Manitowoc **Parts & Service Communicator**

Subject: Danfoss Solenoid Valve Coil Change

Examples Of Previous Coil Versions

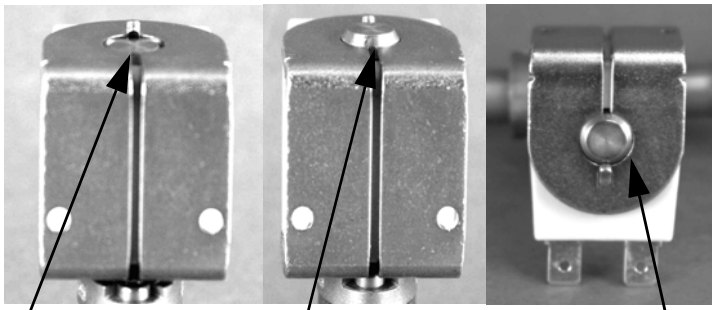
When replacing previous coil versions with latest coil type the o-ring must be removed and discarded. The coil will not seat correctly on the valve stem when the o-ring is present. An snap can be heard as the coil retainer seats. Improper coil seating can lead to erratic valve performance and premature coil failure.

New Style Coil Replaces All Previous Versions

Remove O-ring And Discard Before Installing New Coil

Incorrect - Coil Is Not Seated 100%

Two Views of Correctly Seated Coils Snap Indicates Retainer Has Engaged
